**ADDENDUM NUMBER:** TWO (2)

**DATE:** February 17, 2026

**PROJECT:** LONE OAK COMMUNITY CENTER

**DESIGNER:** BRETT HARBISON, ARCHITECT  
MONTGOMERY COUNTY ENGINEERING

**ADD ALTERNATE #2: LOWER LEVEL ENLARGED PLANS AND ELEVATIONS**

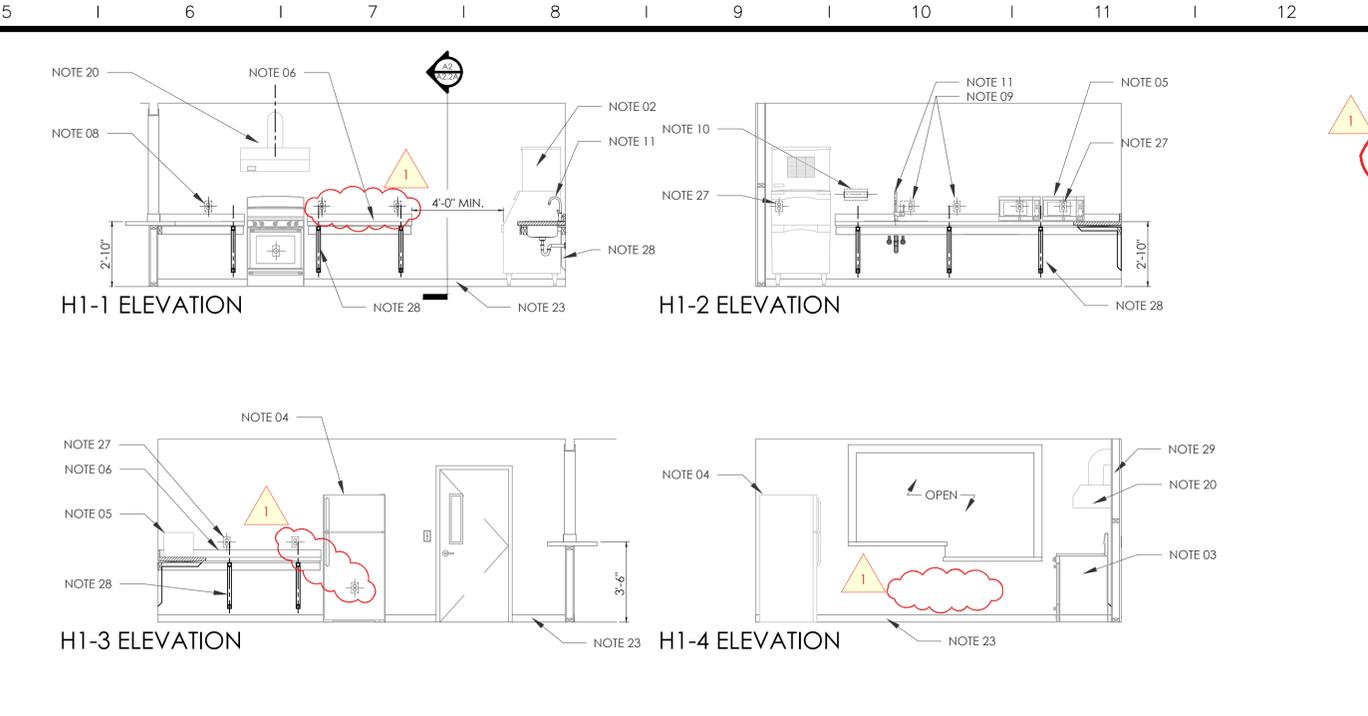
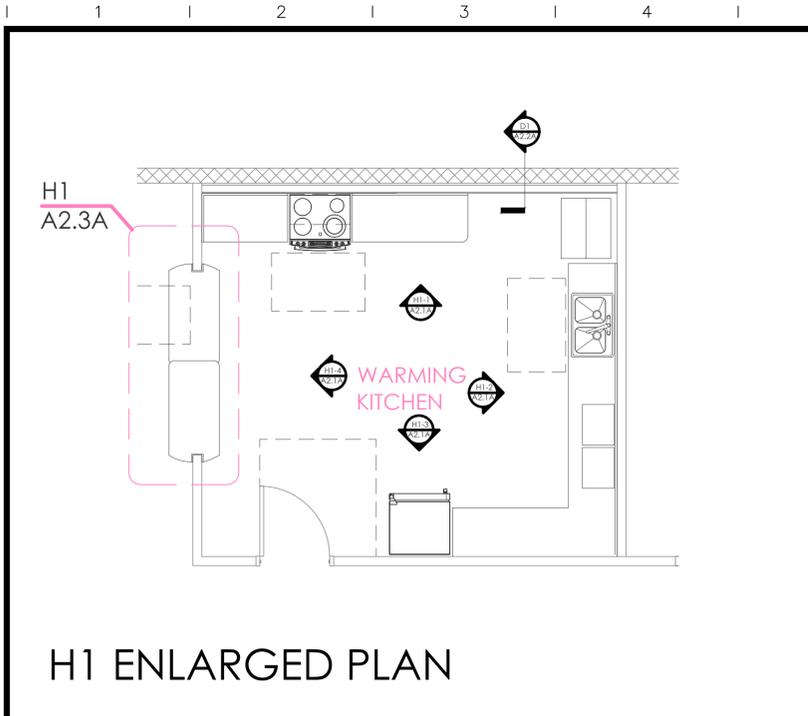
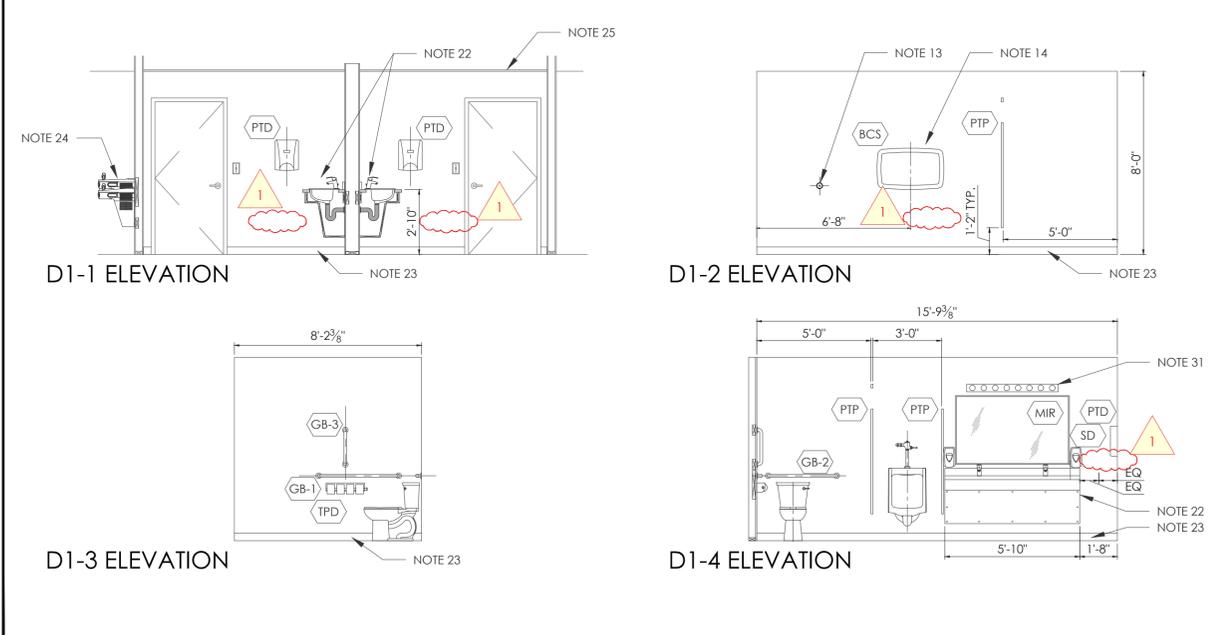
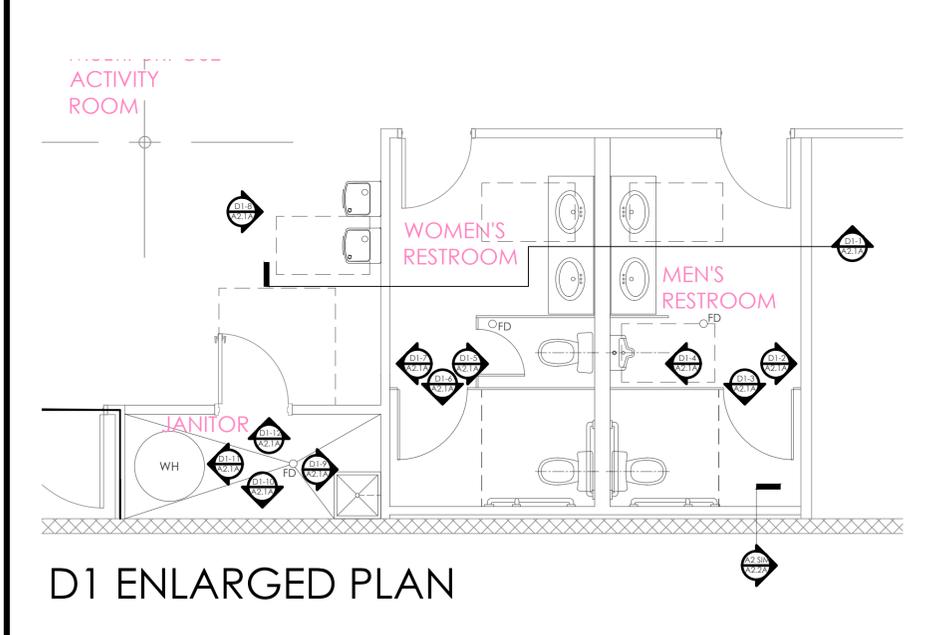
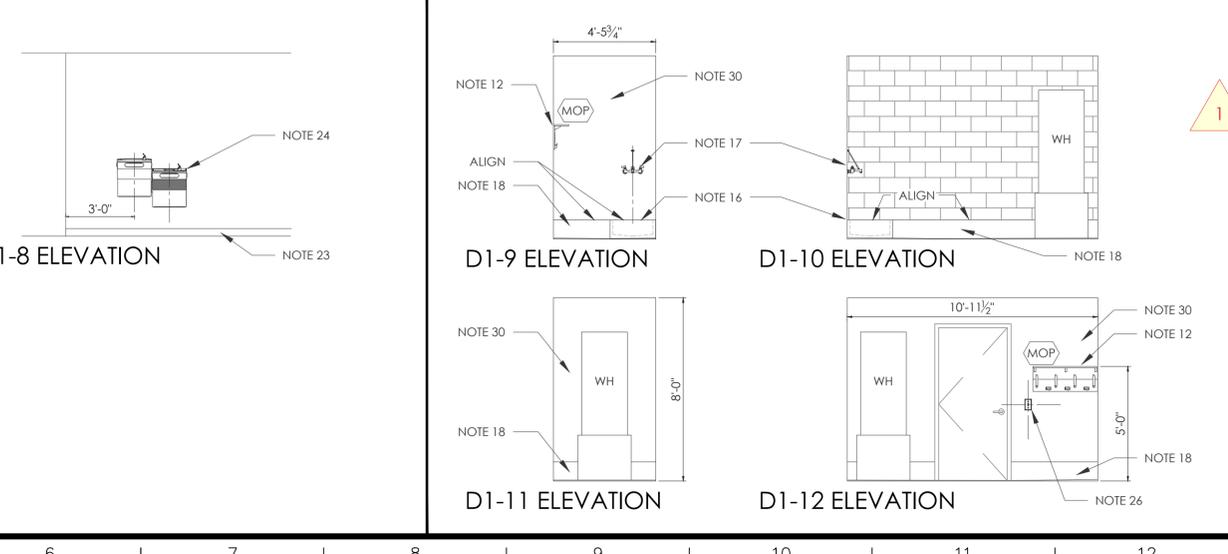
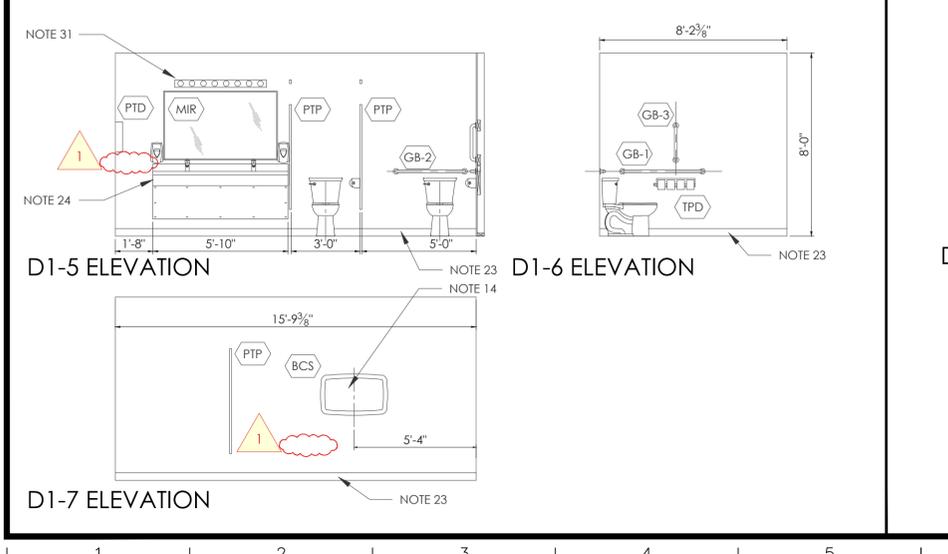
Revised Key Notes 02, 03, 04, 05 to identify these items were Owner Furnished  
Contractor Installed (OFCl).

Revised Legend by adding OFCl - Owner Furnished Contractor Installed.

Revised Toilet Accessories Legend to identify which accessories are Owner  
Furnished Contractor Installed.

D5 SIGNAGE

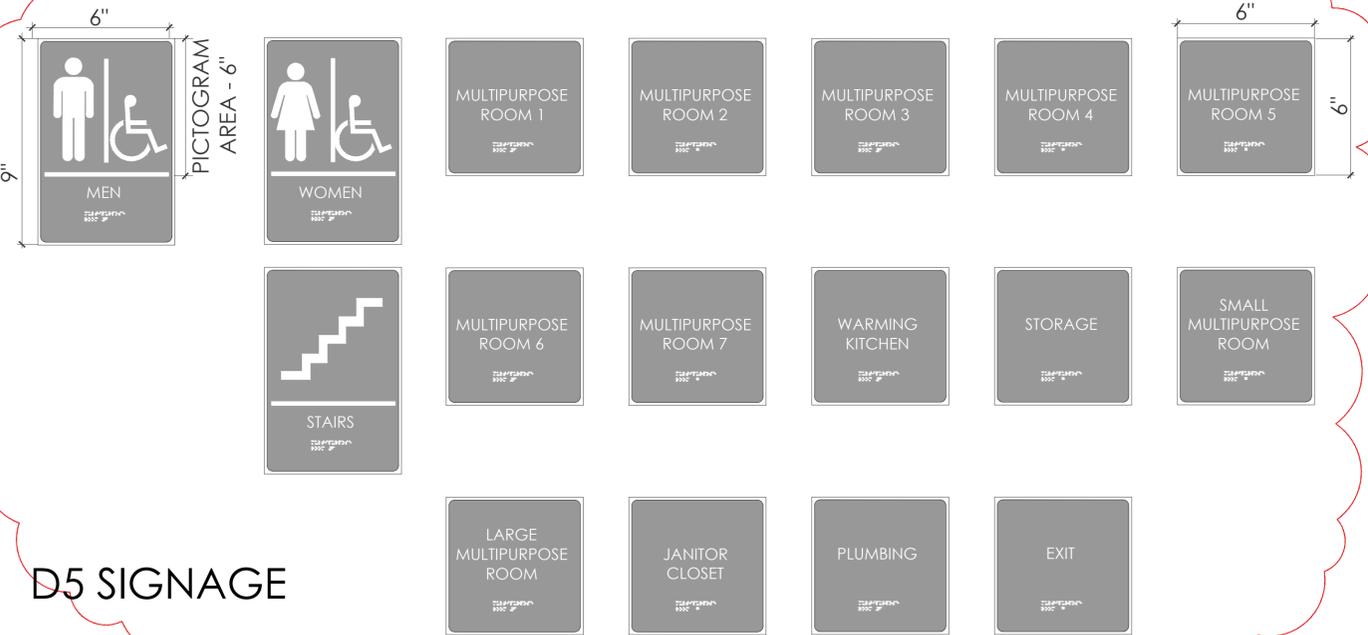
Created Detail D5 SIGNAGE – showing correct signage needed for ADD  
ALTERNATE #2.

**A5.1A**

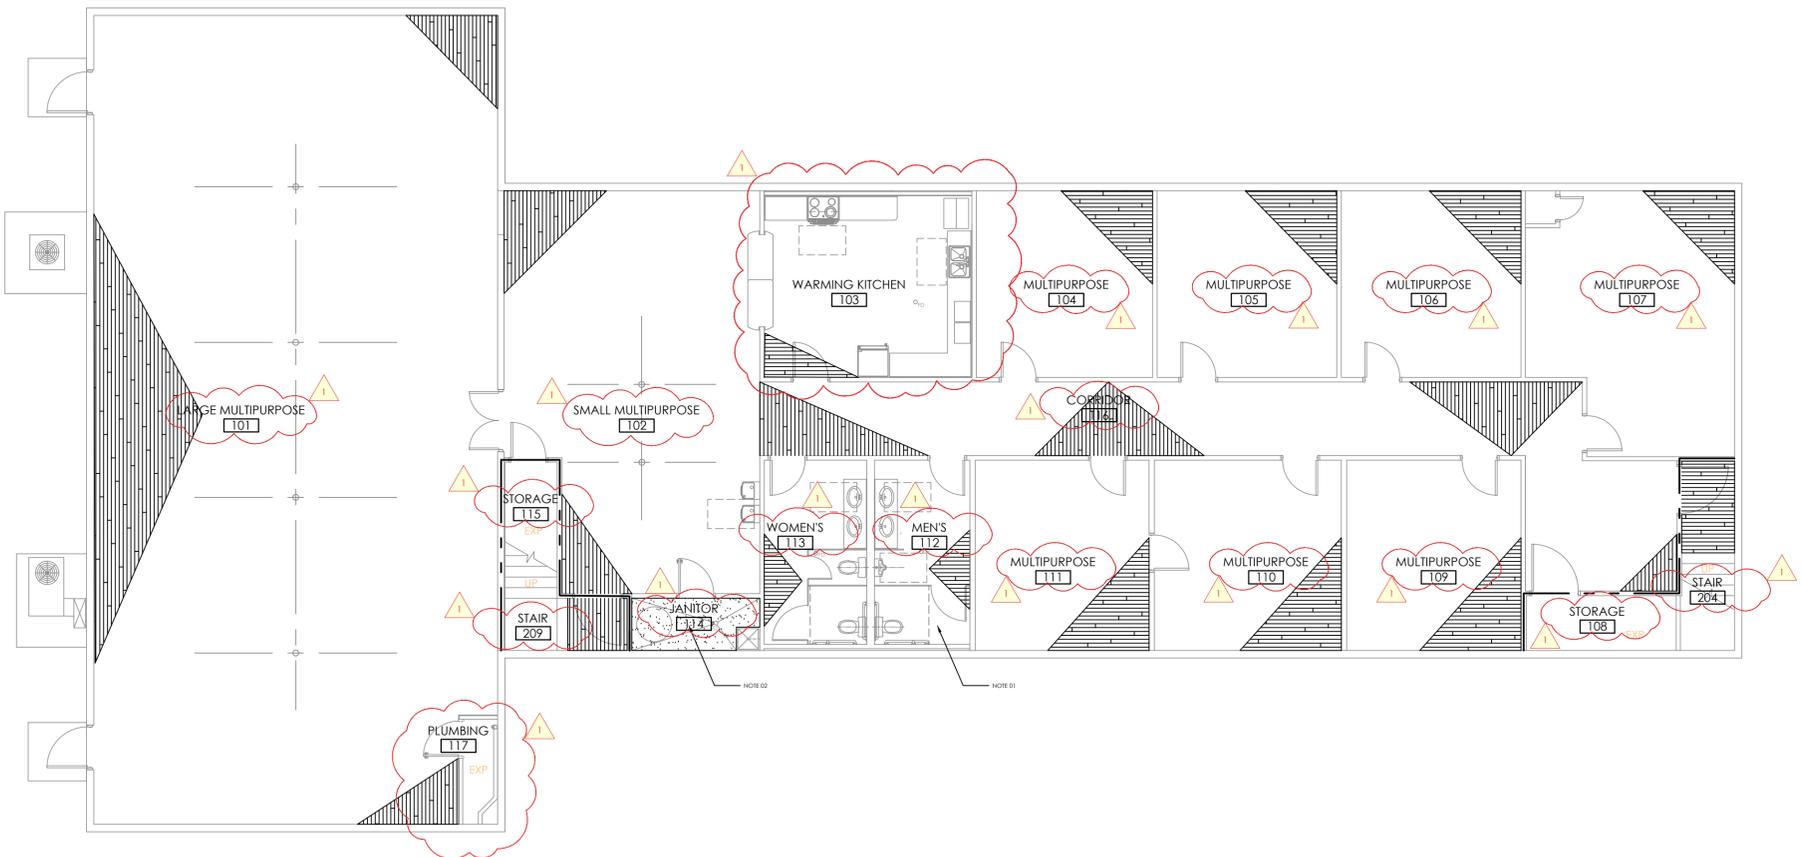
Revised General Note to show LVP.

Revised Legend to show LVP.

Added Room Finish Schedule.

Added correct Room Names and Numbers.
